CITY OF ALBUQUERQUE

RE: **Whataburger
Grading and Drainage Plan
Engineer's Stamp Date 2-18-2015 (File: K10-D001B)**

RE: **Whataburger
Grading Plan
Engineer's Stamp Date 2-18-2015 (File: K10-D001B)**

WHATABURGER
COORS AND CENTRAL
GRADING AND
DRAINAGE PLAN

STORMCHAMBER® TYPICAL CROSS-SECTION INSTALLATION

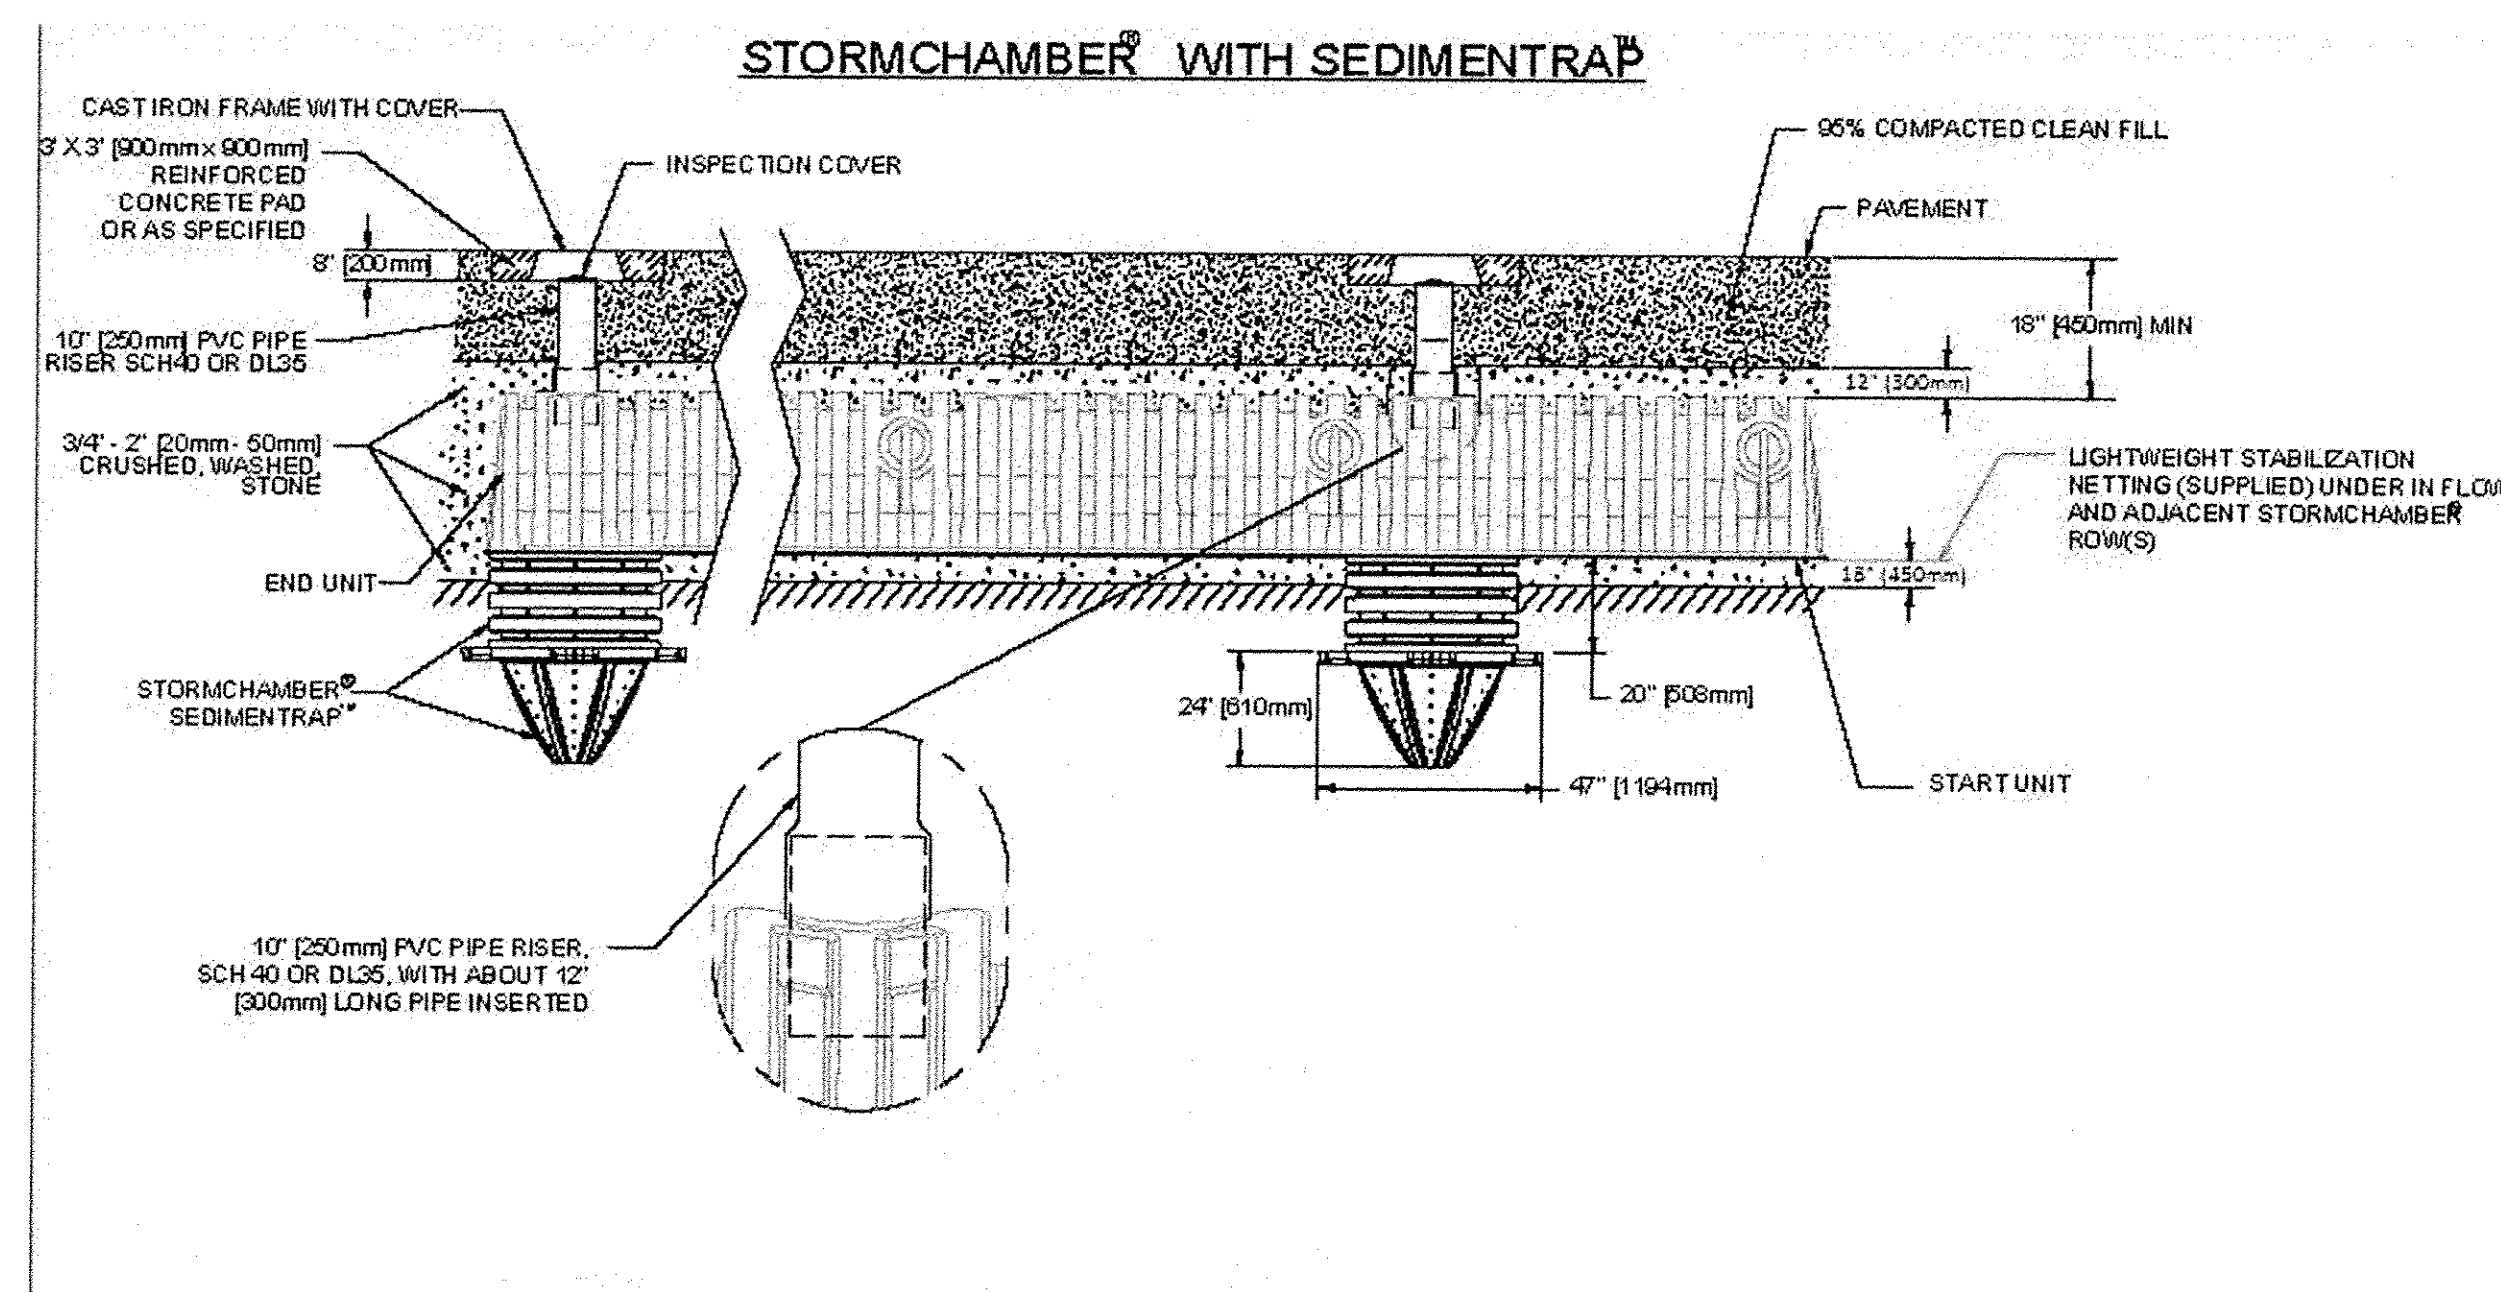
- 9) The number of chambers shown on the "Basin Map and Calculations" sheet is 75. This needs to be called out on the plan view detail on the "Stormchamber Storage System" sheet to make sure the right number of stormchambers will be installed. Also, please provide a legible table showing the layout dimensions for the stormchambers.
